NEW MEXICO OIL CONSERVATION DIVISION

APPLICATION FOR AUTHORIZATION TO INJECT

BTA OIL PRODUCERS, LLC 7811 JV-P Vaca Draw Unit SWD #1 Attachment to C-108 API: 30-025-23895

RE: UIC Question/Vaca Draw Unit SWD Well No. 1

PROPOSED RE-ENTRY WELL DIAGRAM

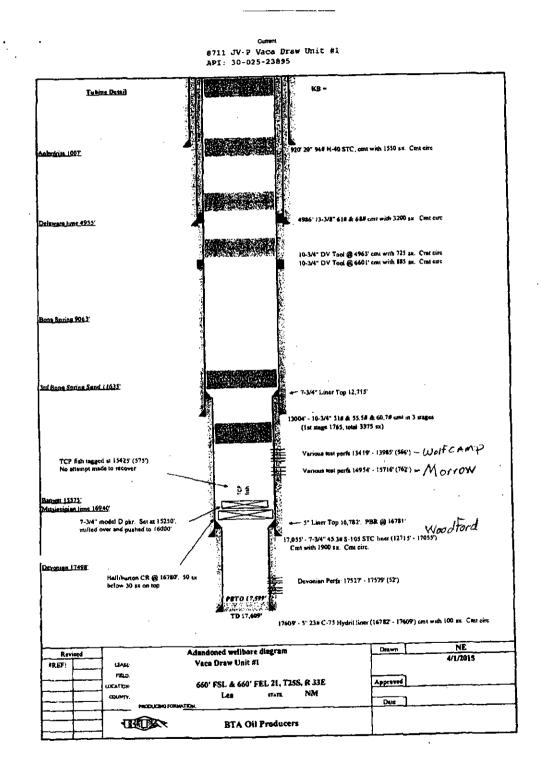
I spoke with Will Jones, and he recommended approval of the Vaca Draw SWD Well No. 1 with the stipulation that BTA run a DV tool at the base of the Wolfcamp formation.

I will also require a CBL through the liner to 12000 feet.

Thank you, I talked to our Drilling Manager, he agreed to the DV tool stipulation and we plan to run a CBL to the referenced depth.
